VIPER 990

NEW OPTIONALS

SHOCKMOUNT SET RR FLEX

S990 #903850

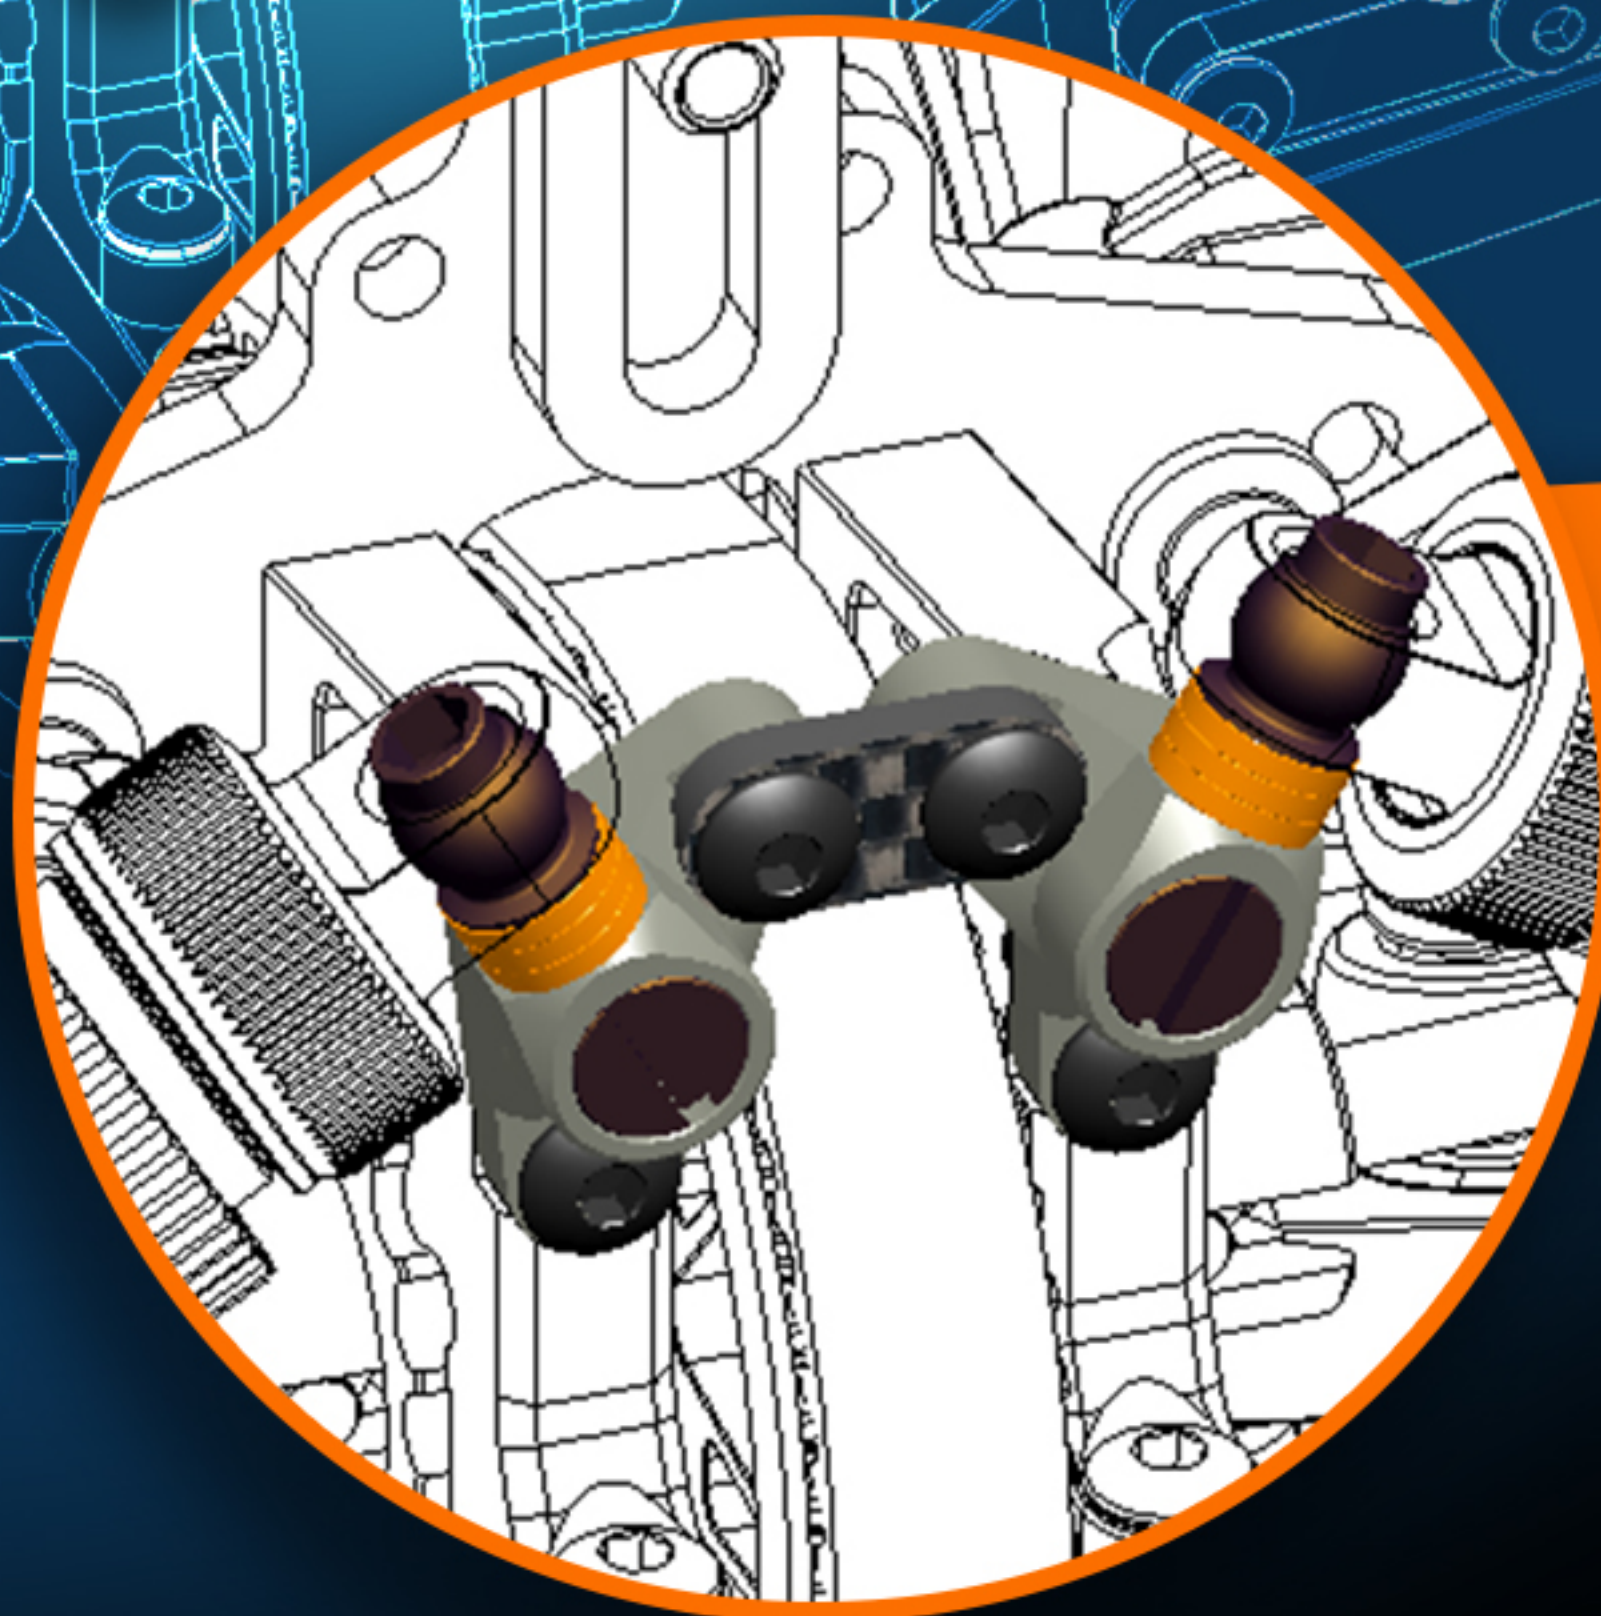
The new optional rear shockmounts allow for more flex.

The traditional shock bracket is replaced by 2 separate mounts. Due to the use of shims, the angle of the shocks can also be adjusted in smaller steps, allowing for an even better suited setup.

The 2 separate mounts can be connected with a bracket to give more stiffness, especially on high traction tracks.
